Product Group: TROWELS

Model: ALL HTX, STX USING DANFOSS INTERFACING LAPTOP SOFTWARE

PITCH CYLINDER CALIBRATION GAUGES UPDATE

Qty 2 – Part # **32000** (2.25") Gauge Tool - Used in calibrating one of the two blade pitch set points as part of the synchronization process, two of these are required per unit.

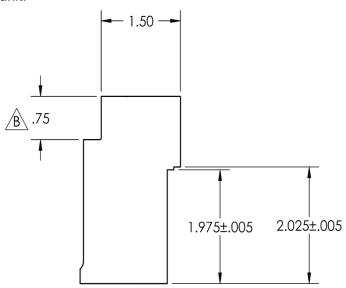
This document is to inform of a production update to the pitch cylinder calibration gauges. The tool's clearance in the following illustrations has been increased from .50" to .75" as of November 2016. This update expands the tools application to include the HTX6H & STX6H units. Pitch cylinder calibration gauges made before November 2016 can be cut to the new specs.
